Prepared for: North Sydney Council
Date: 7 August 2020

6 John Street, McMahon's Point

Berrys Bay Floating Dry Dock Visual Impact Assessment

Figure 73. View P14 (photomontage of dock in raised position with vessel inside and acoustic curtains closed)
Source: Richard Lamb and Associates, dated 7 November 2019

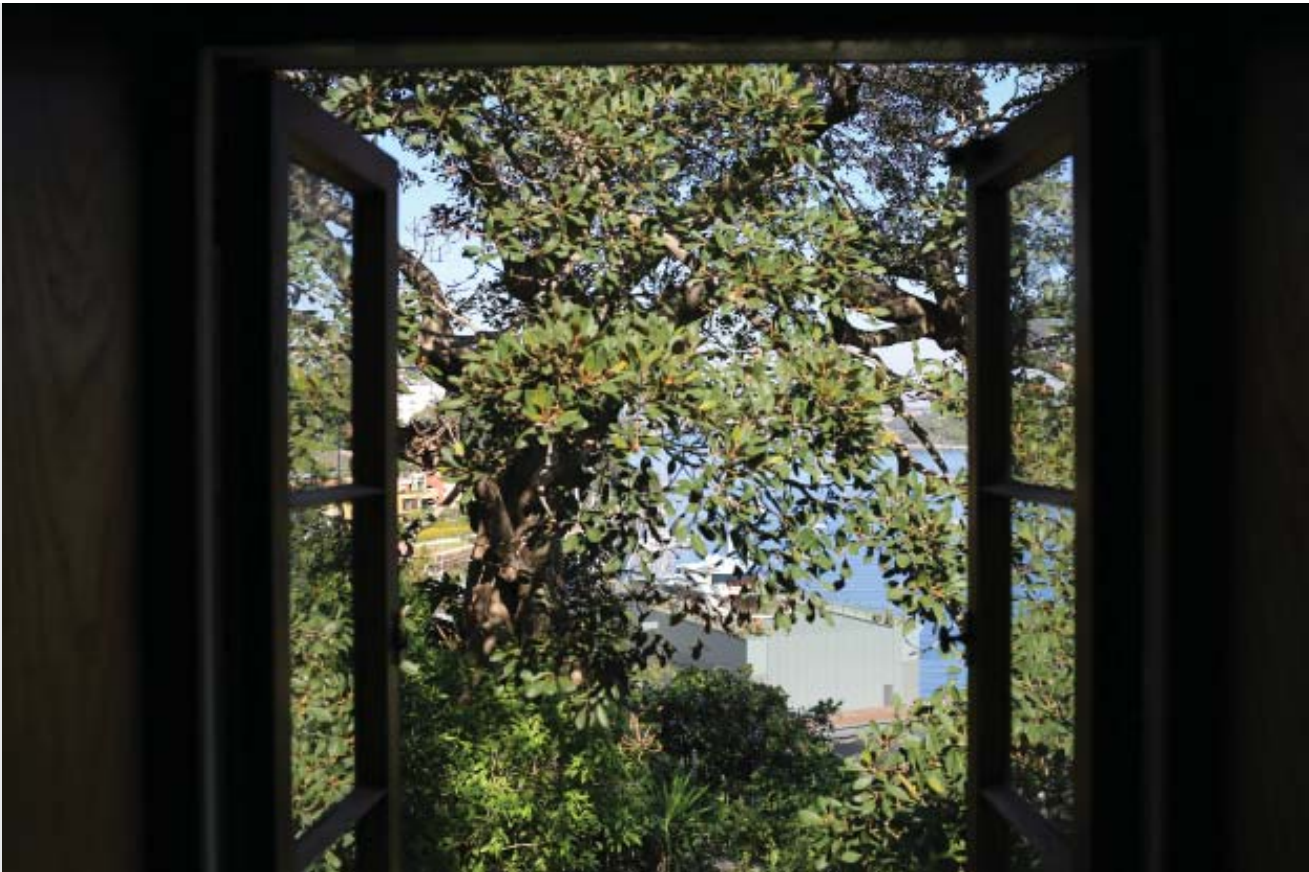
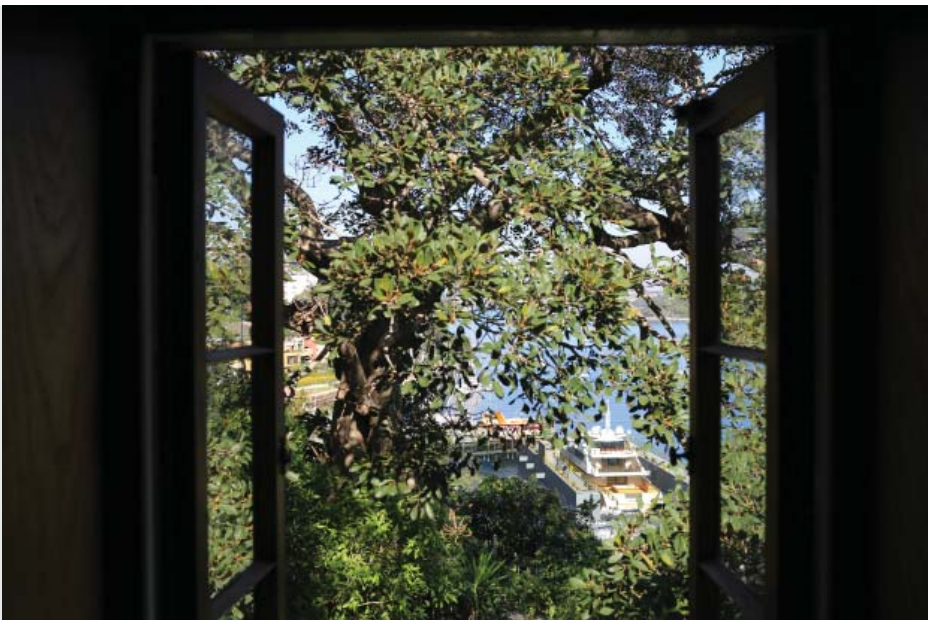
Despite being partly obscured by trees, the proposed floating dry dock will likely be prominent in the view. The view change is considered to be moderate-high.

Summary against criteria:
Importance of view: Moderate
View change: Moderate-High
